A meeting of the **ARGYLL AND BUTE LOCAL REVIEW BODY** will be held in the **BY SKYPE** on **WEDNESDAY, 3 JUNE 2020** at **10:00 AM**, which you are requested to attend.

- 1. APOLOGIES FOR ABSENCE
- 2. DECLARATIONS OF INTEREST
- 3. CONSIDER NOTICE OF REVIEW REQUEST: LAND SW OF 1 ROYAL COTTAGE, PIER ROAD, INNELLAN (REF: 20/0008/LRB)
 - (a) Notice of Review and Supporting Documentation (Pages 3 18)
 - (b) Comments from Interested Parties (Pages 19 54)

REVIEW AGAINST REFUSAL OF PLANNING PERMISSION REF. 19/01861/PP

Reference No:	19/01861/PP
Planning Hierarchy:	Local application
Applicant:	Mr Stuart Hutcheson
Proposal:	Erection of dwellinghouse and installation of sewage treatment plant.
Site Address:	Land south-west of 1 Royal Cottage, Pier Road, Innellan, Argyll.

[Production No. 1 Appeal Site Location Plan]

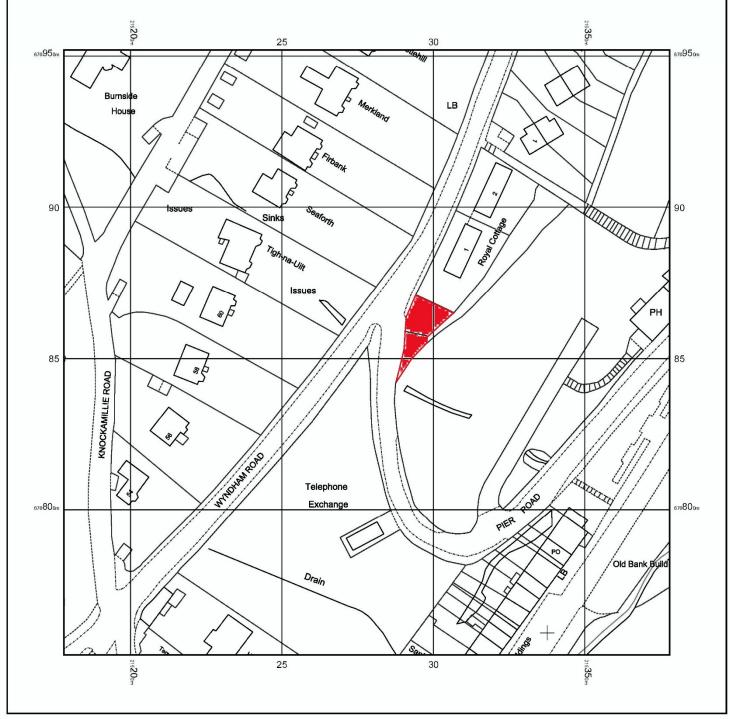
${\ensuremath{\mathbb S}}$ Crown copyright and database rights 2019 Ordnance Survey 100048957. The representation of road, track or path is no evidence of a boundary or right of way. The representation of features as lines is no evidence of a property boundary.
